# LAND PARK COMMERCIAL CENTER PROJECT (P15-048) FINAL ENVIRONMENTAL IMPACT REPORT (SCH# 2015112025)

**Land Park Commercial Center Project (P15-048)  
Final Environmental Impact Report (SCH# 2015112025)**

Figure 1: Alternative site layout of project buildings recommended by HPNA.

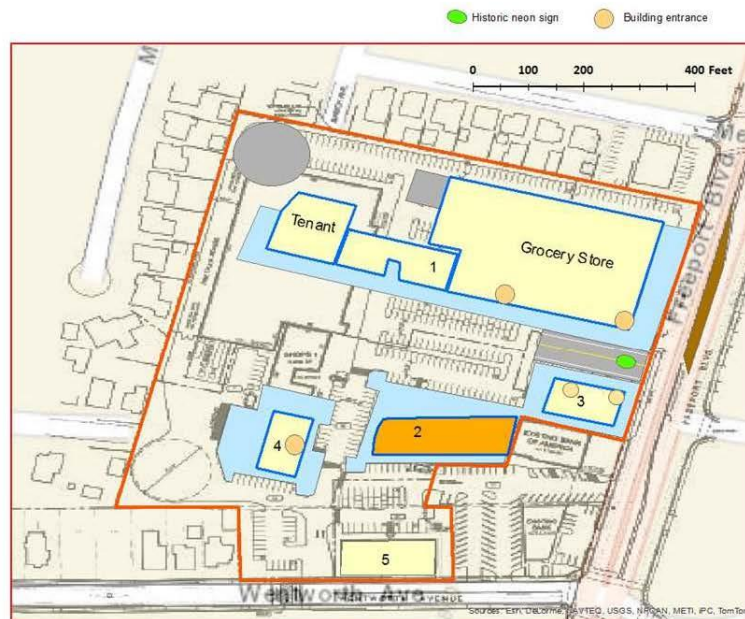
The HPNA feels that the alternative that sites the grocery store along the north boundary of the project site (as we recommend in comments above, see attached Figure 1), adjacent to and perpendicular to Freeport Boulevard, was not fully vetted, and therefore, we request a more detailed consideration of such an alternative. Since Alternative 3 was found to have similar or less impacts than the proposed project, it is likely that the northern boundary alternative siting would have similar impacts with similar opportunities for mitigation. As stated in comments above, the northern boundary alternative would also be more consistent with the 2035 General Plan, will likely promote greater public safety, discourage crime, facilitate pedestrian and bicycle access, and allow more traffic mitigation options.
